From: "Selim" <Selim@sawayaeng.com>
To: "'Ron Dragoo'" <RonD@rpvca.gov>
Cc: "SoK@rpvca.gov" <SoK@rpvca.gov>, "Jill Martin" <jmartin@trumpnational.com>, "'Ara Mihranian'" <AraM@rpvca.gov>, "Scott Campbell" <scampbell@trumpnational.com>
Subject: 2019-06-18 # Tract 50666 # Request for Storm Drain Amendment

Re: **Request to use Forestall Canyon to convey off-site storm water in lieu of the proposed 60 inch Reinforced Concrete Pipe.**

EXHIBIT "A"
TRACT 50666
PRE-DEVELOPMENT
EXISTING STORM DRAIN

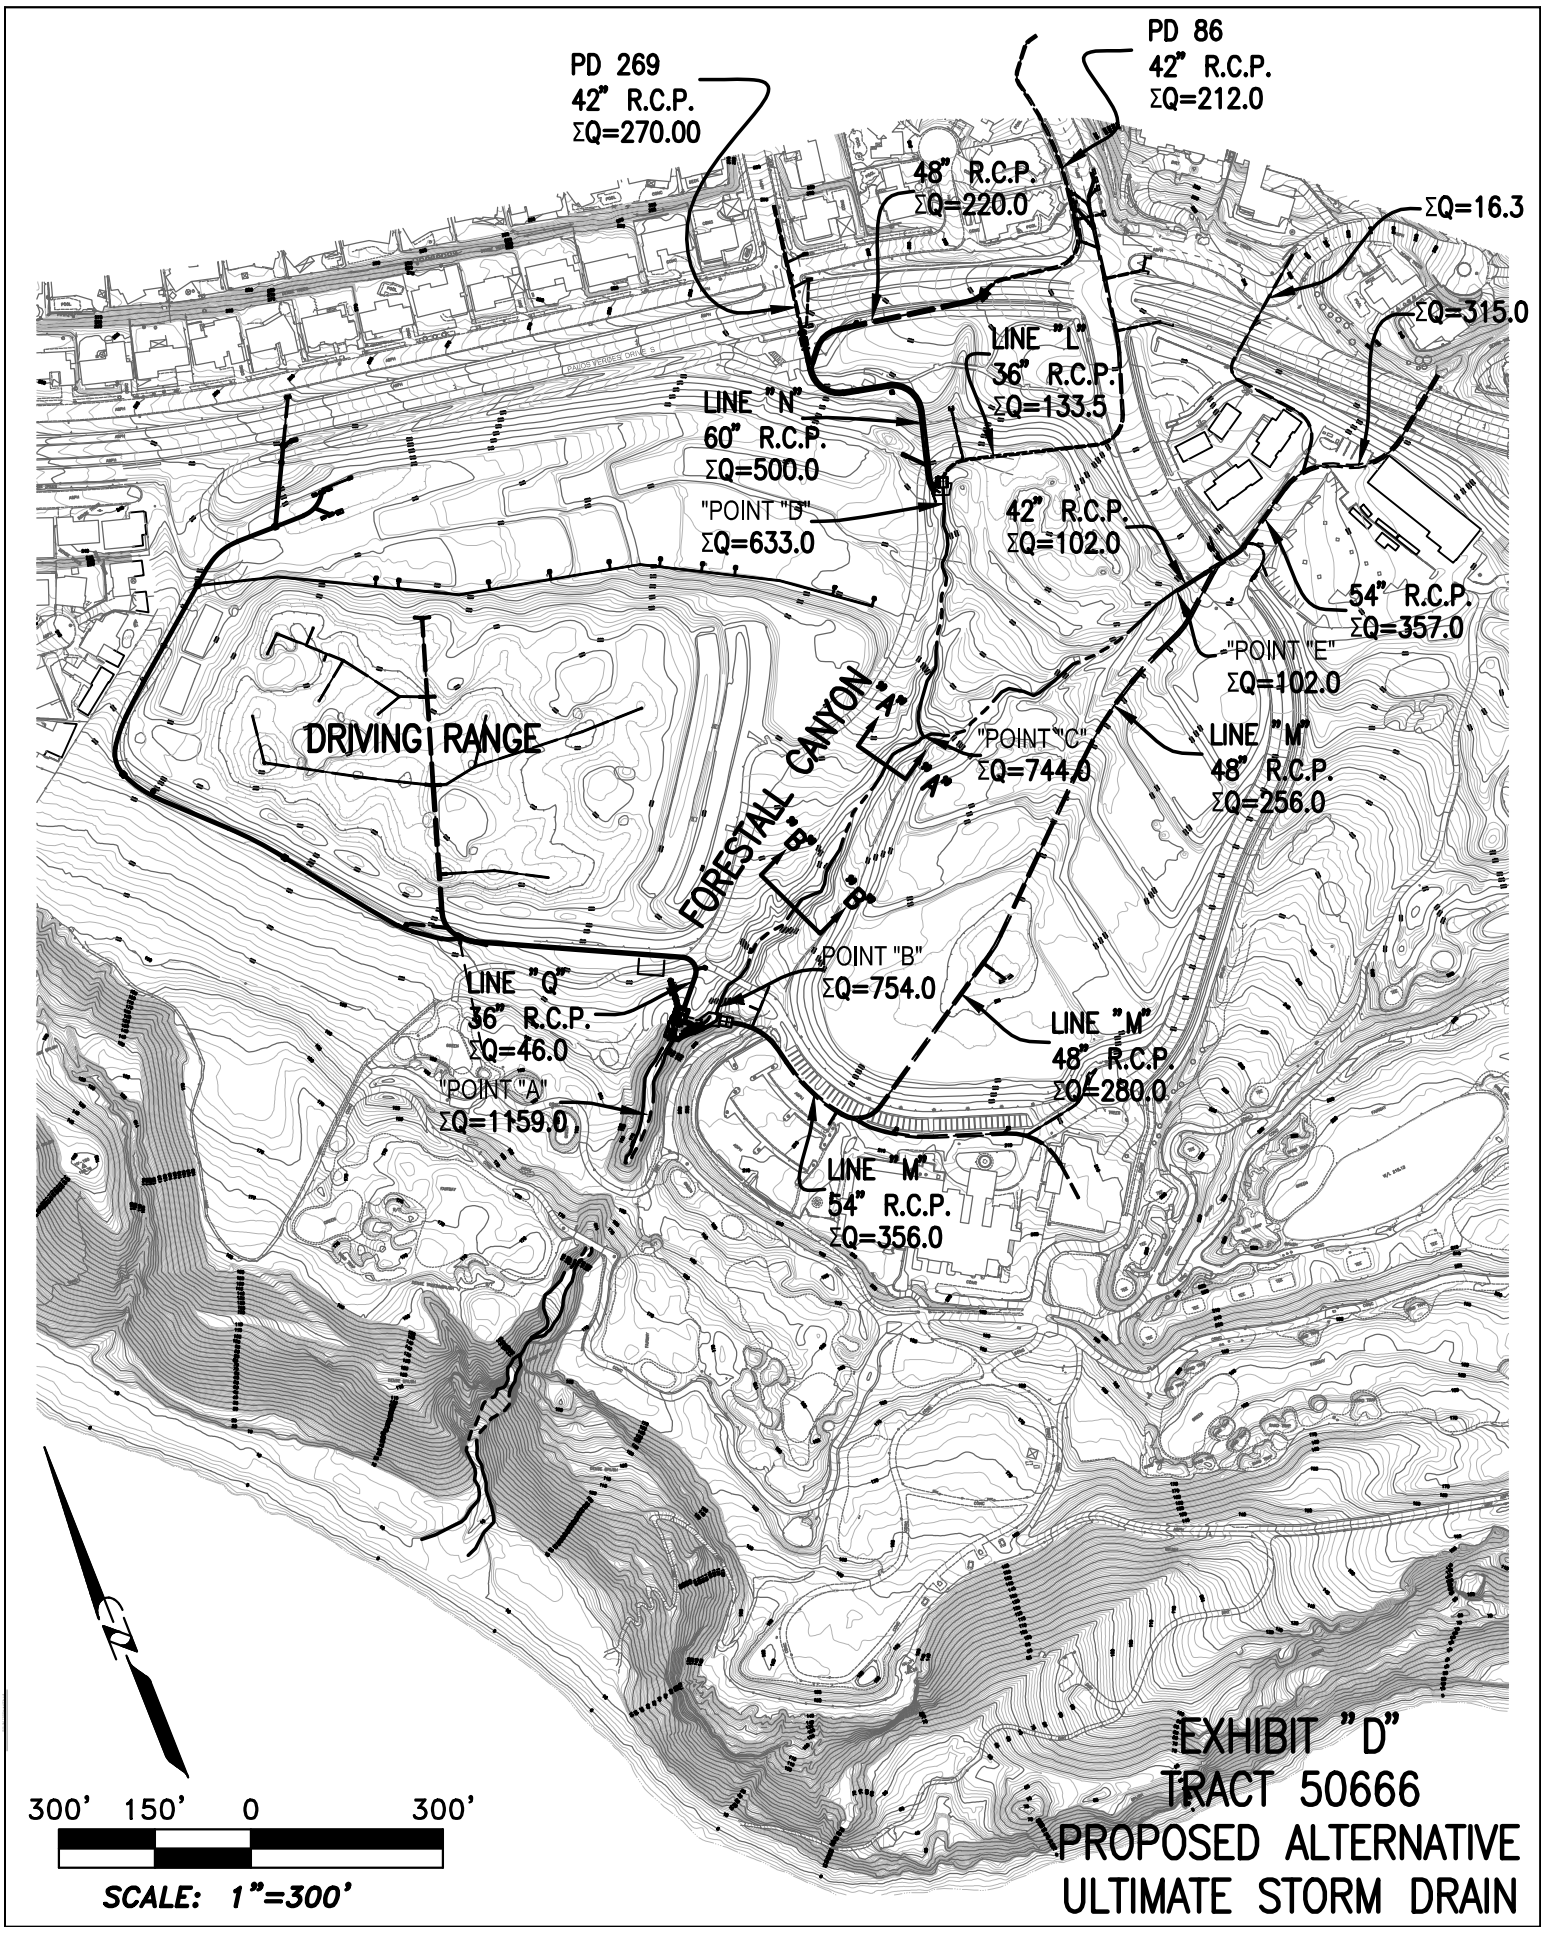
In 2005, an amended loting configuration for the site was approved and graded to provide for a driving range in lieu of 16 residential lots, thus reducing the number of residential lots west of Forestall Canyon from 29 to only 13 lots. The amended site as approved and graded has reduced and likely eliminated the risk of residential flooding from Forestall Canyon rendering the proposed Line "N" (60" RCP) redundant and unnecessary. Therefore, VH Property is requesting the City of Rancho Palos Verdes' approval to eliminate the portion of Line "N" that is adjacent to Forestall Canyon from Point "B" to Point "D".

1. The proposed ultimate flow of Forestall Canyon would be approximately 72% of historical (Predevelopment at Point "B" is 1050 cfs – Post development at Point "B" is 754 cfs).
2. The proposed ultimate flow of Forestall Canyon would be equal to the current/interim flow.
3. Forestall Canyon has performed well under the current/interim condition for the past 15 years.
4. No Residential lots would be at risk from flooding and high velocity scouring action.
5. Forestall Canyon has the capacity to carry the anticipated flow with a velocity less than 15 fps. (See Exhibit "E" for Hydraulic Calculation).
6. Since PD 86 and PD 269 are debris carrying line, Forestall Canyon is more suitable to carry the flow rather than a storm drain pipe.

EXHIBIT "E"
TRACT 50666
PROPOSED ALTERNATIVE
HYDRAULIC CALCULATION

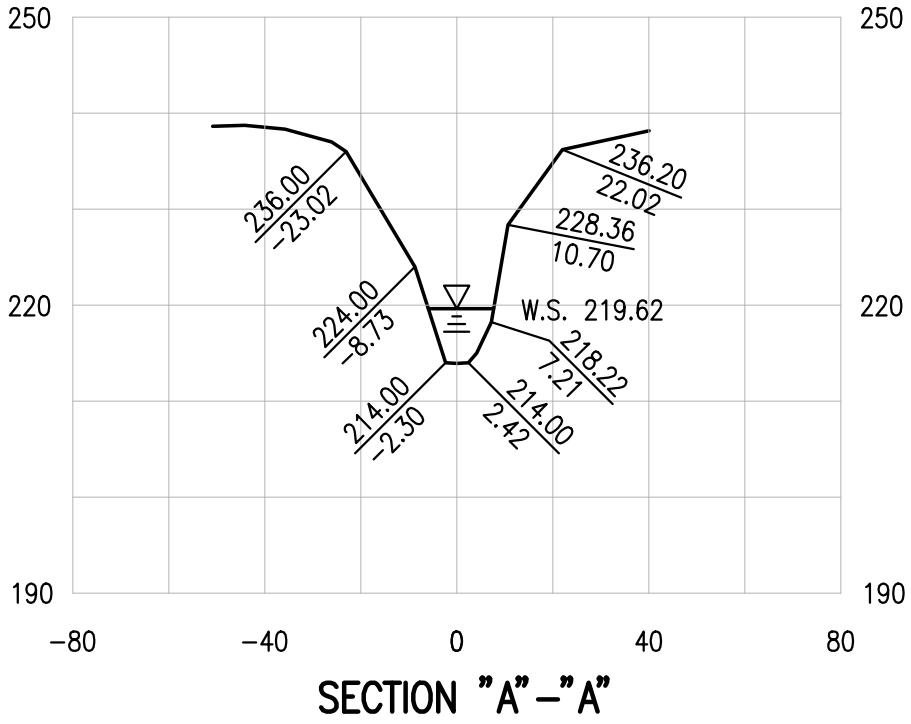
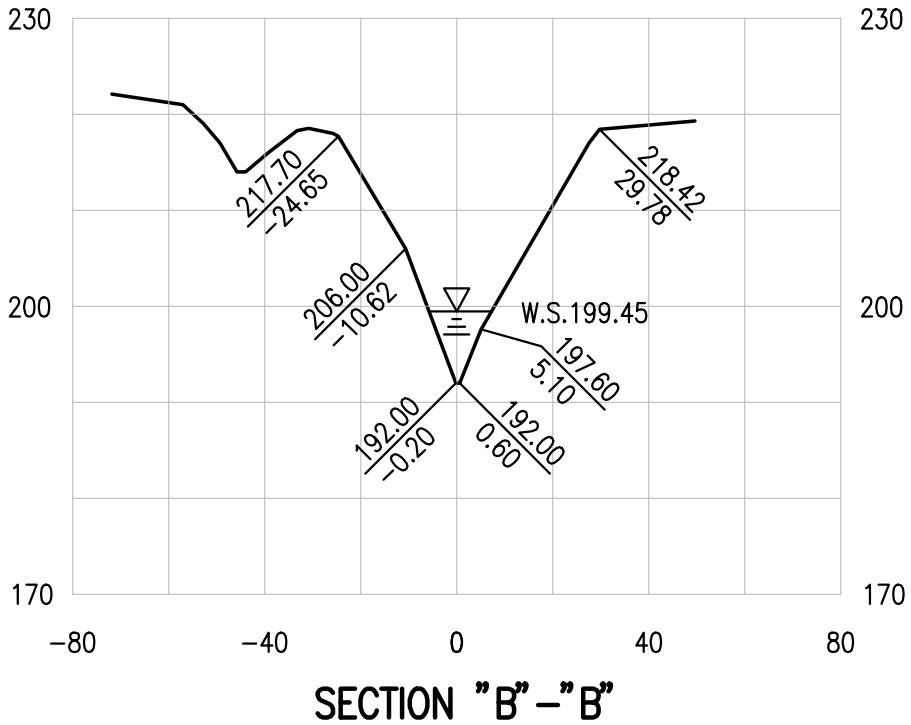
INPUT DATA
Channel Slope 0.043500 ft/ft
Elevation range: 214.00 ft to 236.20 ft.
Discharge 735.00 cfs

RESULTS
Wtd. Mannings Coefficient 0.045
Water Surface Elevation 219.62 ft
Flow Area 53.81 ft²
Wetted Perimeter 19.26 ft
Top Width 13.60 ft
Height 5.62 ft
Critical Depth 220.21 ft
Critical Slope 0.029653 ft/ft
Velocity 13.66 ft/s
Velocity Head 2.90 ft
Specific Energy 222.52 ft
Froude Number 1.21
Flow is supercritical.

INPUT DATA
Channel Slope 0.064000 ft/ft
Elevation range: 192.00 ft to 218.42 ft.
Discharge 754.00 cfs

RESULTS
Mannings Coefficient 0.045
Water Surface Elevation 199.45 ft
Flow Area 49.53 ft²
Wetted Perimeter 20.13 ft
Top Width 13.03 ft
Height 7.45 ft
Critical Depth 200.50 ft
Critical Slope 0.032121 ft/ft
Velocity 15.22 ft/s
Velocity Head 3.60 ft
Specific Energy 203.05 ft
Froude Number 1.38
Flow is supercritical.
